SUBJECT: Transmittal of Corrections to EPRI Report 3002005349, *Materials Reliability Program: Pressurized Water Reactor Internals Inspection and Evaluation Guidelines (MRP-227, Revision 1)*

Subject: **Transmittal of Corrections to EPRI Report 3002005349, Materials Reliability Program: Pressurized Water Reactor Internals Inspection and Evaluation Guidelines (MRP-227, Revision 1)**

Fig 1
 Typical CE Welded Core Shroud Designs Assembled in Two Vertical Sections (with Top-Mounted ICI)

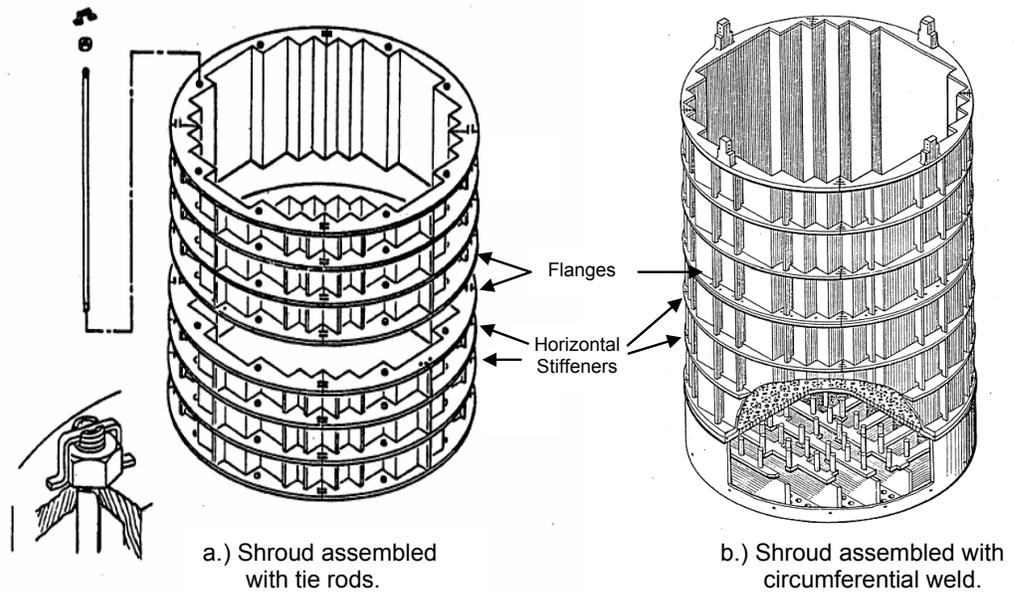
On pages 3-8 (Figure 3-3), 3-9 (Figure 3-4) and 4-47 through 4-68 (Figures 4-11 through Figure 4-37), the figure captions have been modified to improve clarity. These are general representations of the internal components, and the word ‘typical’ has been added to the beginning of each figure caption.

*Figure 4-26
Typical CE-Design Core Shroud Assembly (Welded) Assembly and Core Shroud Plate-Former
Plate Weld*

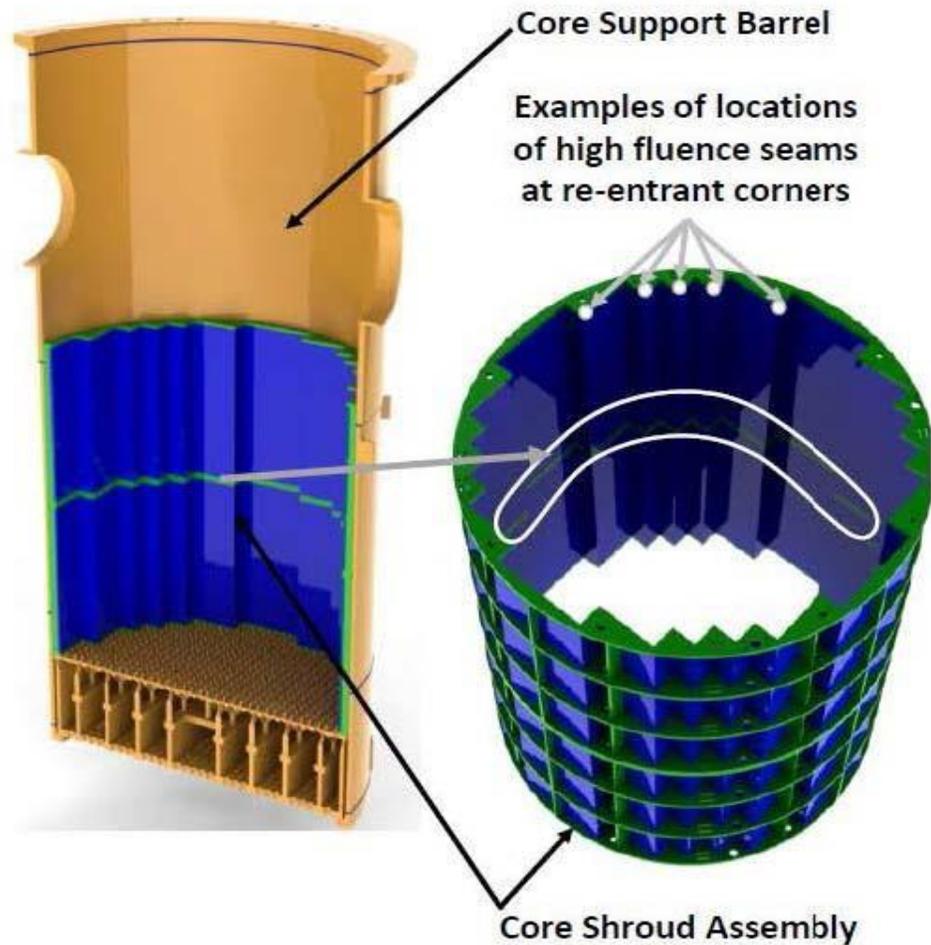
MRP-227 Revision 1 Figure call-out errors identified in Table 4.5			
Entry	Page Number	Erroneous call-out	Corrected call-out
C1.2	4-28	4-35	4-34
C5.1	4-28	4-29	4-29 and 4-30
C5.4	4-28	4-36	4-35
C1.1	4-29	4-37	4-36
C2.1	4-29	4-38	4-26
C3.1/3.2	4-29	4-38	4-37
C11.1	4-29	4-33	4-32

Expansion Item	Applicability	Effect (Mechanism)	Primary Link (Note 1)	Examination Method/Frequency (Note 1)	Examination Coverage
Core Shroud Assembly (Bolted) C1.1.Core support column bolts	Bolted plant designs	Cracking (IASCC, Fatigue) Aging Management (IE)	C1.Core shroud bolts	Ultrasonic (UT) examination. Re-inspection every 10 years following initial inspection.	100% (or as supported by plant-specific analysis) of core support column bolts (Minimum of 75% of the total population). See Figure 4-36.
Core Shroud Assembly (Welded) C2.1.Remaining axial welds	Plant designs with core shrouds assembled in two vertical sections	Cracking (IASCC), Aging Management (IE)	C2.Core shroud plate-former plate weld	Enhanced visual (EVT-1) examination. Re-inspection every 10 years following initial inspection.	75% of the remaining axial weld length and adjacent base metal as visible from the core side of the shroud other than that already inspected under the primary link. See Figure 4-26.

Figure 4-28
 Typical CE-Design Core Shroud Assembly (Bolted) Assembly

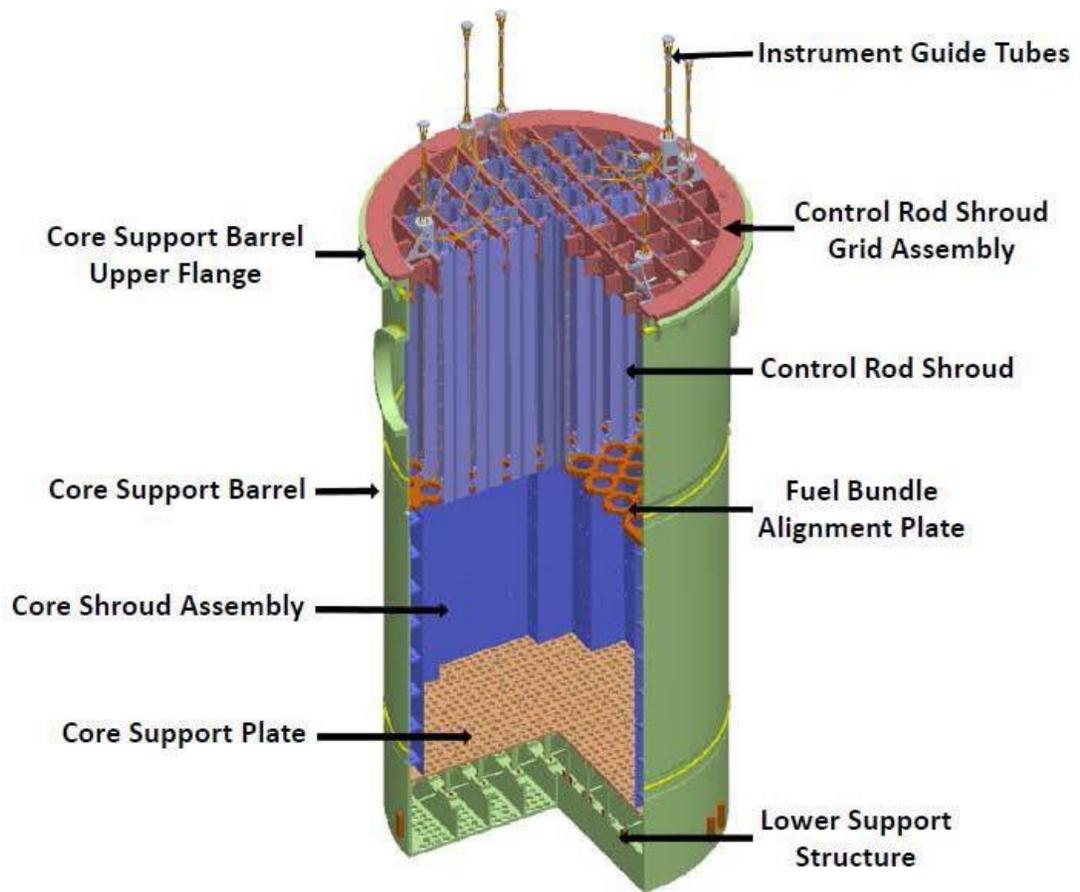
MRP-227 Revision 1 Figure call-out errors identified in Table 4.2			
Entry	Page Number	Erroneous call-out	Corrected call-out
C8.	4-19	4-31	4-36
C9.	4-19	4-31	4-28
C10.	4-20	4-32	4-31
C11.	4-20	4-33	4-32
C12.	4-20	4-34	4-33

C9.Lower Support Structure Core support plate	All plants with a core support plate	Cracking (Fatigue) Aging Management (IE)	None	If screening for fatigue cannot be satisfied by plant-specific evaluation, enhanced visual (EVT-1) examination, no later than 2 refueling outages from the beginning of the license renewal period. Subsequent examination on a ten-year interval.	Examination coverage to be defined by evaluation to determine the potential location and extent of fatigue cracking. See Figure 4-28
